BEFORE THE PUBLIC SERVICE COMMISSION
OF THE STATE OF MISSOURI

In the Matter of Union Electric Company)
d/b/a Ameren Missouri’s 2020 Utility) File No. EO-2021-0021
Resource Filing Pursuant to 20 CSR 4240)
– Chapter 22)

SIERRA CLUB’S COMMENTS ON
AMEREN MISSOURI’S 2020 INTEGRATED RESOURCE PLAN

Figure 2: Ameren’s 2020 IRP Probability Tree¹⁹

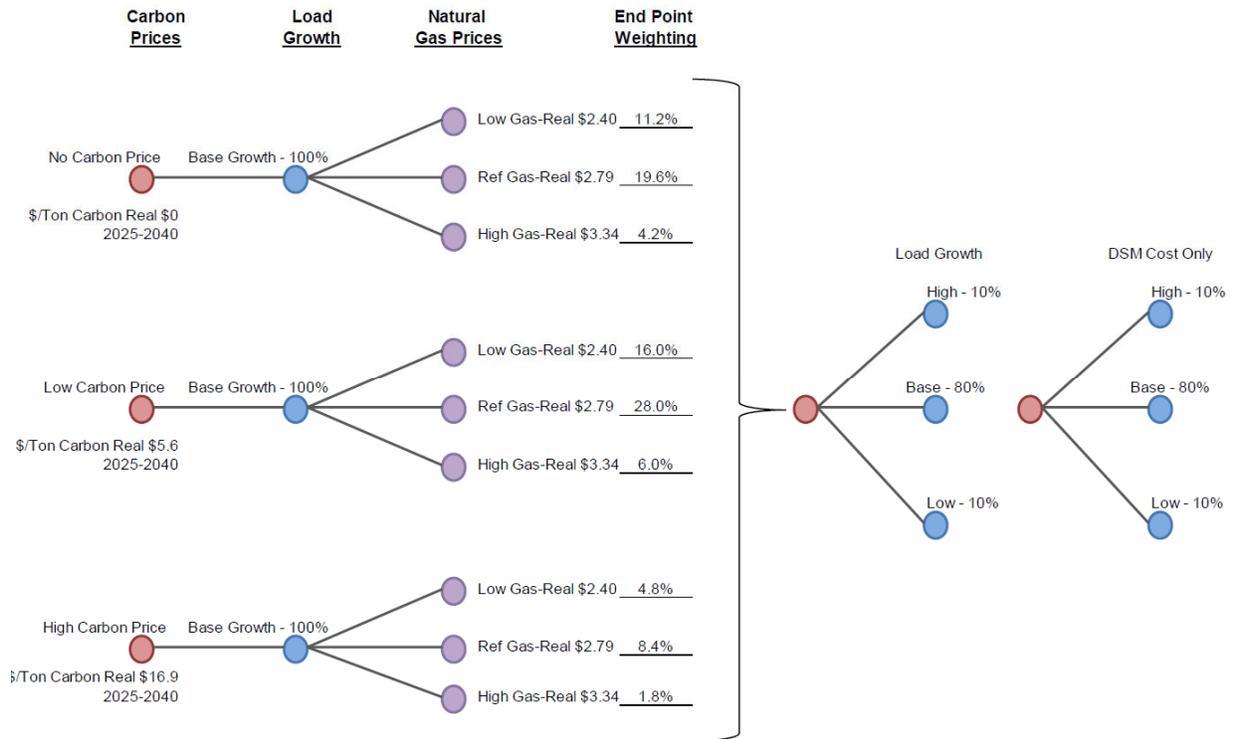
This decision-tree process is problematic because the amount of coal generation and renewable energy additions on the system are pre-determined by the carbon price set by Ameren. This level of coal-fired and renewable energy resources is then set-in-stone no matter what the load or gas prices are in subsequent steps. This is backwards logic because, in reality, coal retirement decisions and renewable energy additions are heavily influenced by load growth and prices for MISO energy (which are themselves largely influenced by gas prices). This impact has been apparent in recent years: low load growth and low gas price have led to significant coal unit retirements across the United States. Thus, Ameren’s retirements and capacity buildout should be dynamic with these key market factors.

To remedy this deficiency, Ameren should update its approach to modeling by removing its hard-coded, pre-determined coal retirements and resource additions, and allow new supply-side and demand-side resources to compete against its existing resources in every year of the 2020s starting with 2022.

Figure 5: Solar PV Capital Costs (nominal \$kW, unsubsidized)⁴⁴

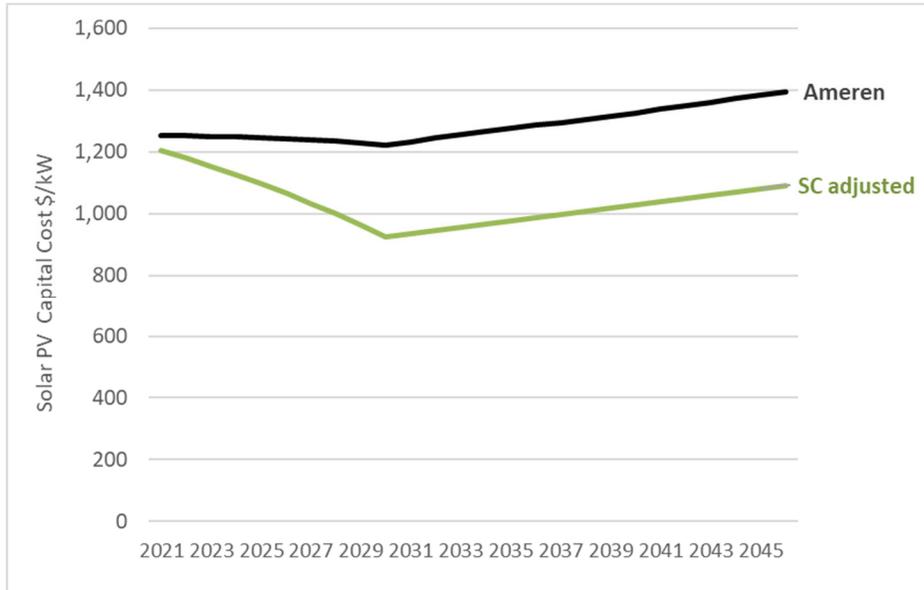
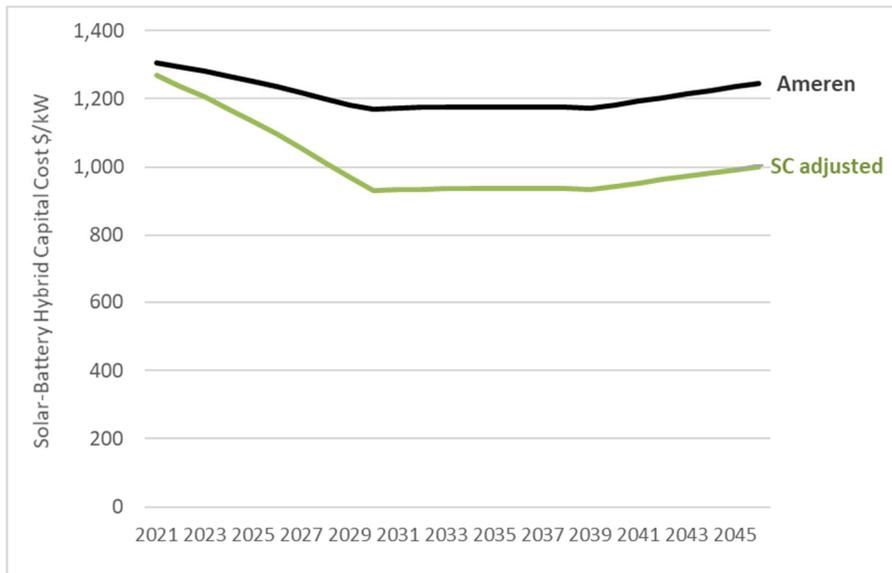
We updated the solar PV and battery cost assumptions to account for more up-to-date capital cost and tax credit information. Ameren projected solar capital costs (\$/kW) using the annual decline in costs reported in the NREL 2019 Annual Technology Baseline (“ATB”),⁴³ but now the 2020 ATB is available. After substituting the updated NREL data, the costs of solar and solar-battery hybrids were substantially lower than what is being assume in the IRP—as shown in Figure and Figure below.

Figure 7: EIA New Renewable Capacity Projections (2019 AEO vs. 2021 AEO)⁷²

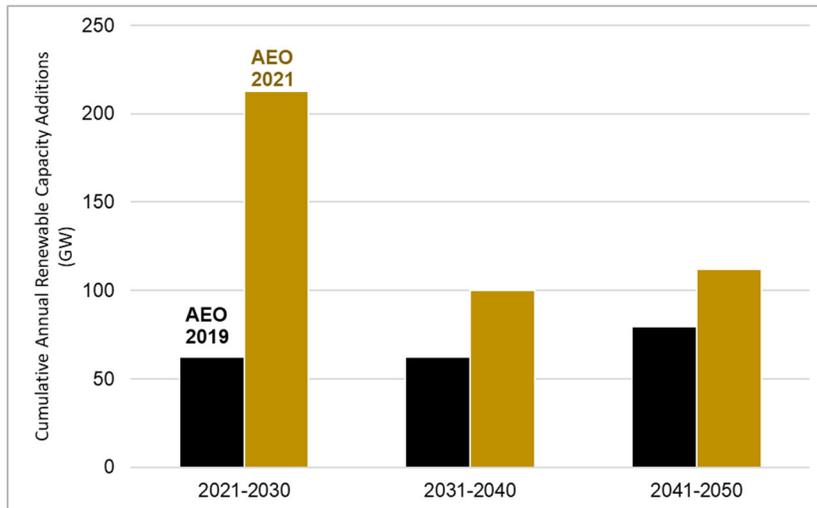
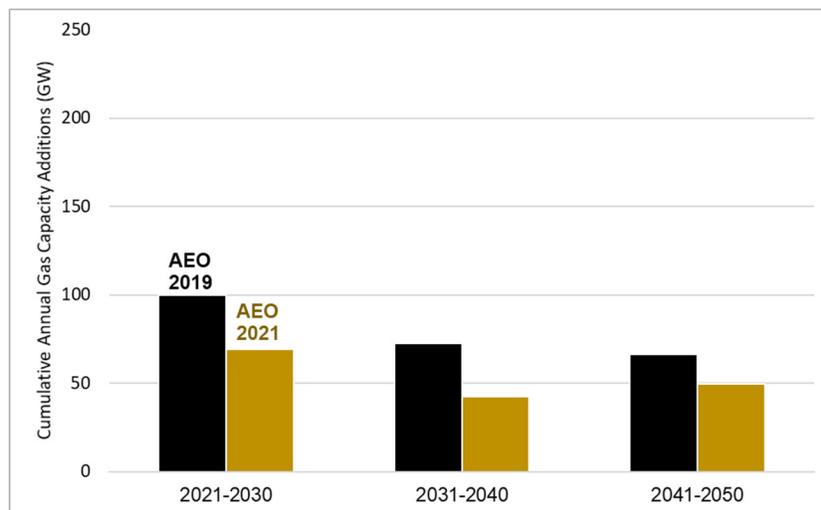
As discussed, almost all of the plans modeled in the IRP added new NGCC which was effectively treated as the default replacement option. Ameren claimed that an NGCC was going to be the “marginal source” for new generation through 2050—citing the Energy Information Administration (“EIA”).⁷⁰ However, Ameren’s outlook is outdated as is the source it used to justify this decision. The Company cited to the 2019 Annual Energy Outlook (“AEO”) from the EIA which projected slightly more gas than renewable capacity would be installed from 2021 through 2050.⁷¹ However, the latest 2021 AEO projects substantially more new renewable installations compared to gas. This swing in the EIA’s outlook is shown below in Figure (which shows new renewable capacity) and Figure (which shows new gas capacity).

Clearly, renewables are closer to being a “marginal resource” than natural gas. The EIA now expects that new renewable capacity will be more than double new gas capacity over the
